VICINITY MAP: M-10-Z
LEGAL DESCRIPTION:
LOT 2, COORS ARENAL INDUSTRIAL PARK

ENGINEER'S SEAL DAVID SOULE P.E. #14522	LOTS 2-COORS ARENAL INDUSTRIAL PARK		DRAWN BY WCWJ
	TRAFFIC CIRCULATION LAYOUT		DATE 9-01-10
 Rio Grande Engineering 1808 CENTRAL AVENUE SUITE 201 ALBUQUERQUE, NM 87106 (505) 872-0999		21129-LAYOUT-8-25-11	
		SHEET #	
		JOB # 21129

ENGINEER'S SEAL	6811 HUSEMAN	DRAWN BY WCWJ
DAVID SOULE NEW MEXICO 14522 REGISTERED PROFESSIONAL ENGINEER	GRADING AND DRAINAGE PLAN	DATE 10-06-11
	Rio Grande Engineering 1606 CENTRAL AVENUE SUITE 201 ALBUQUERQUE, NM 87106 (505) 672-0899	21129-LAYOUT-B-25-11
DAVID SOULE P.E. #14522	RECEIVED DEC 2 2012	JOB # 21129

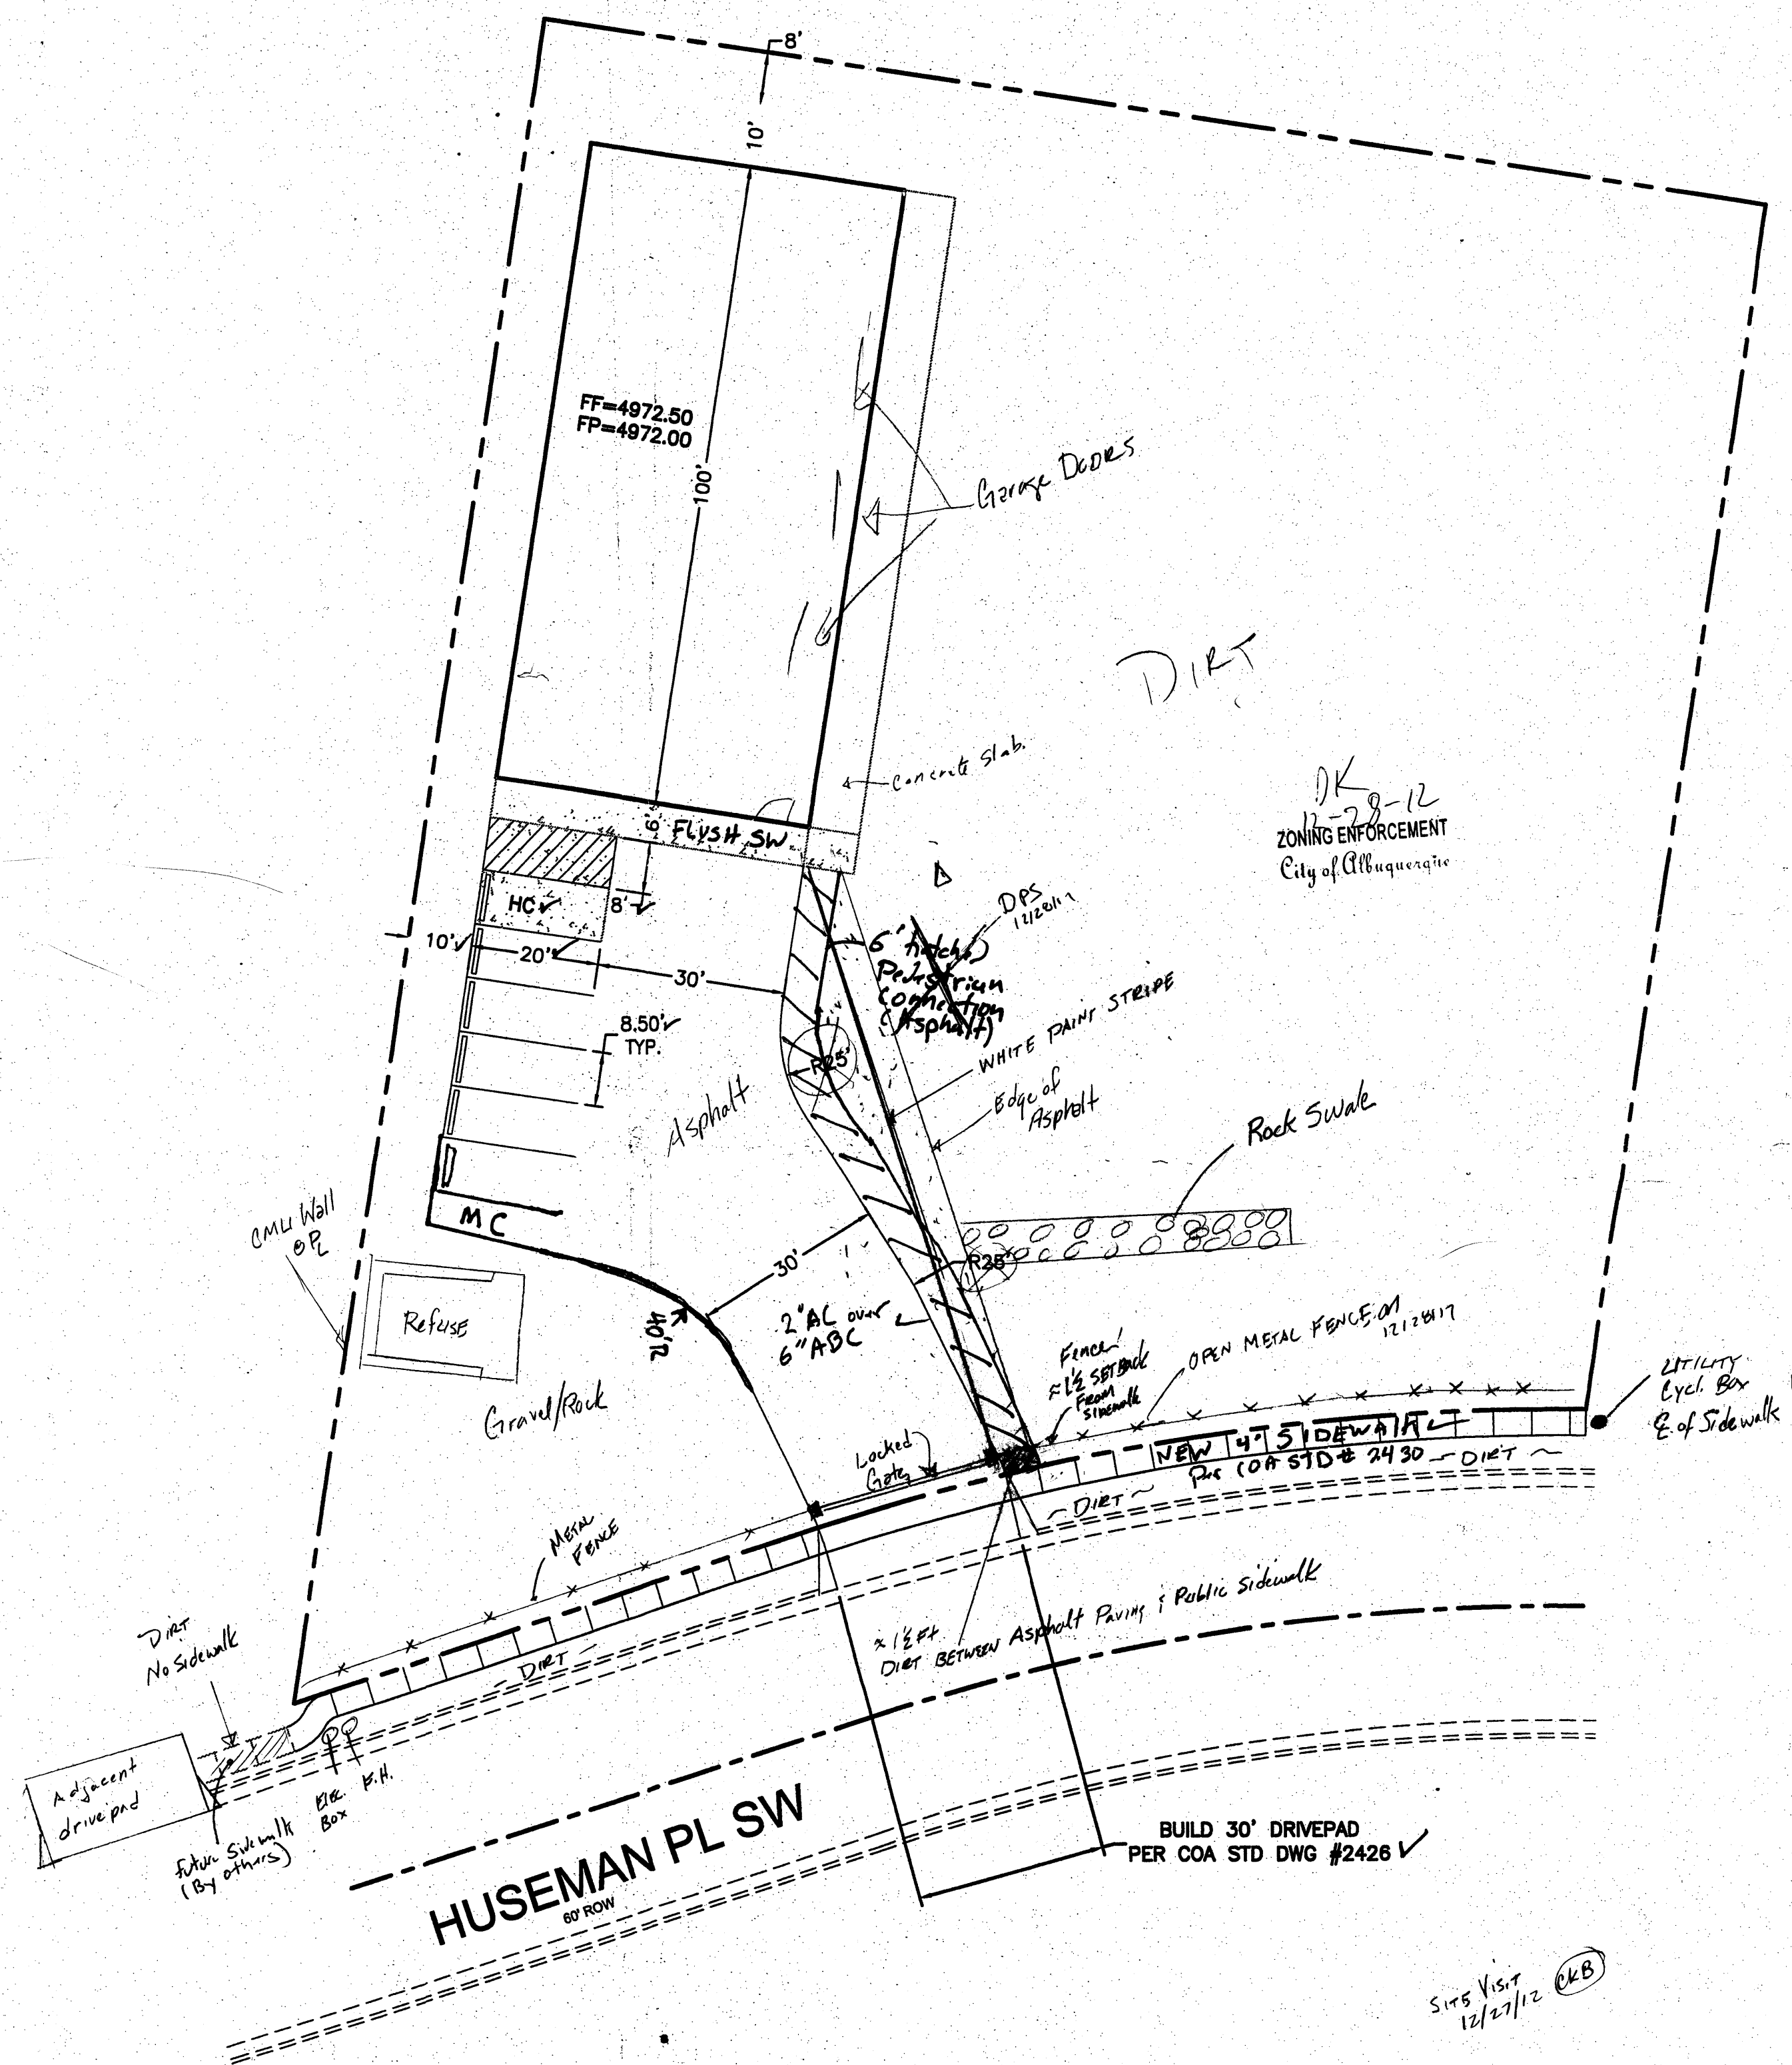
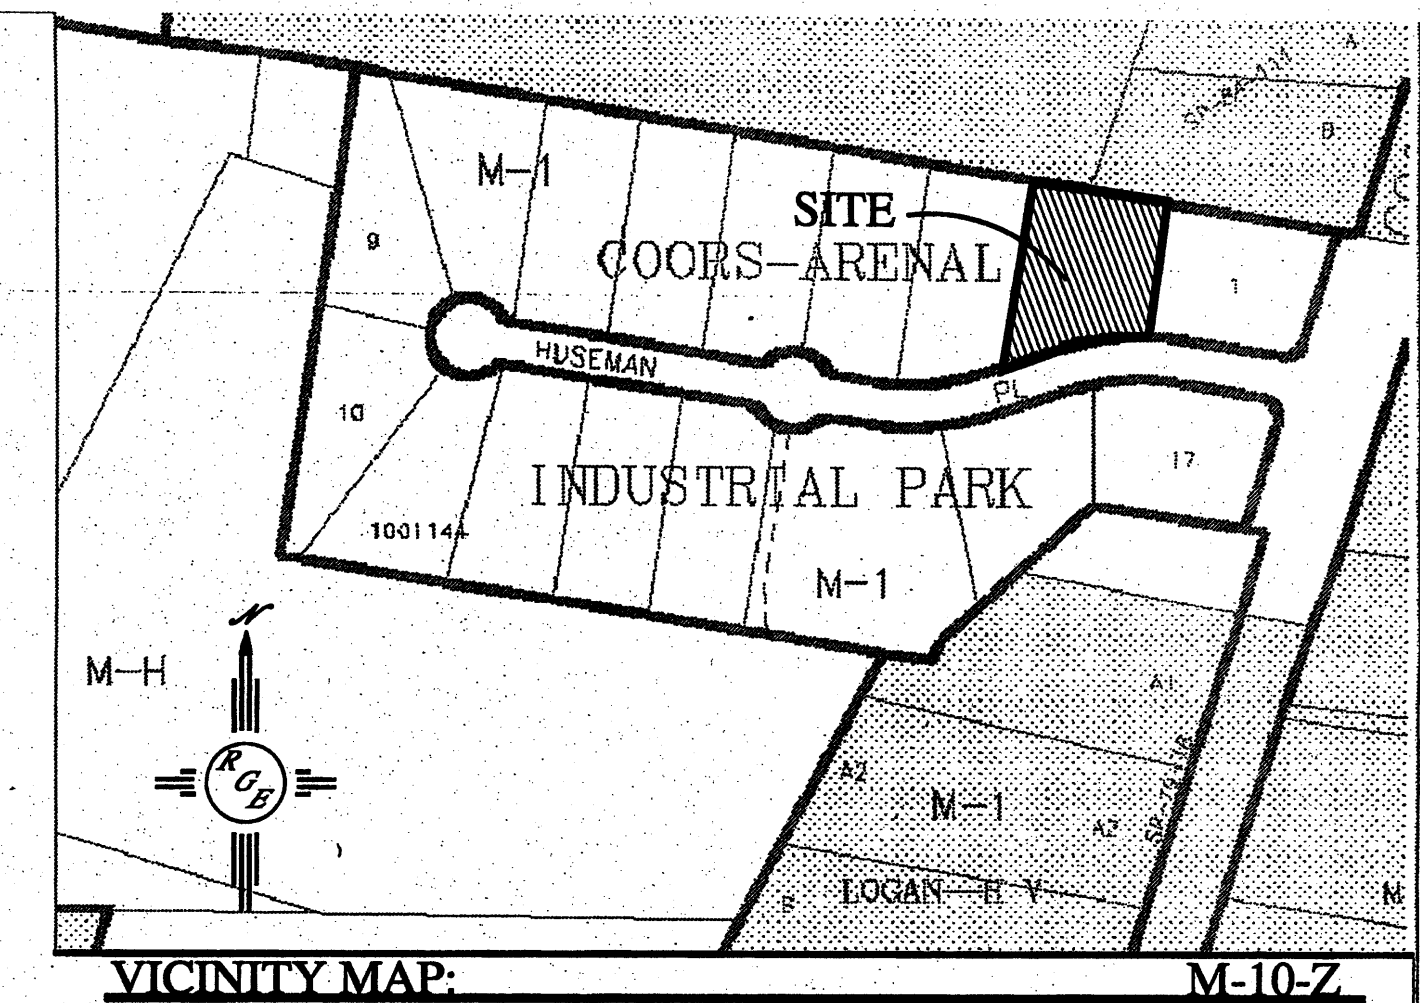
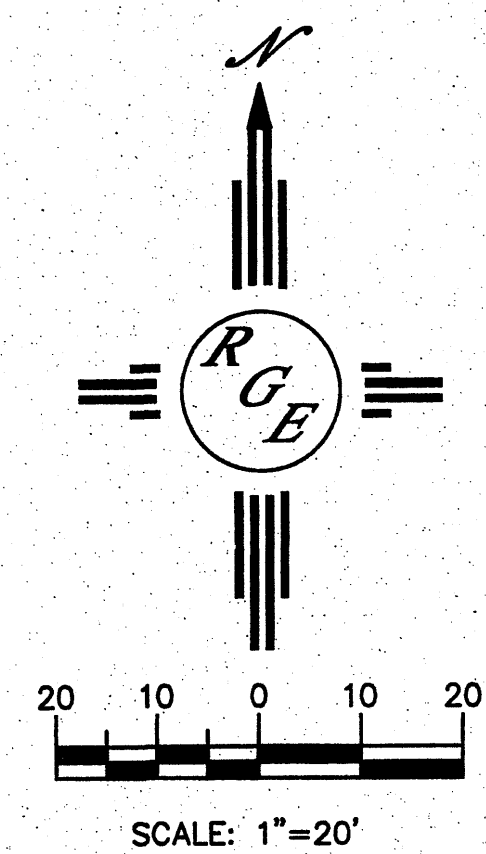
R.A. Called 12/28/12, missing
Please come in "Red-line"
Submitted Plans to reflect
As David O'Zoning will
sign-off that No 6' pedestrian
path is Req. ekb
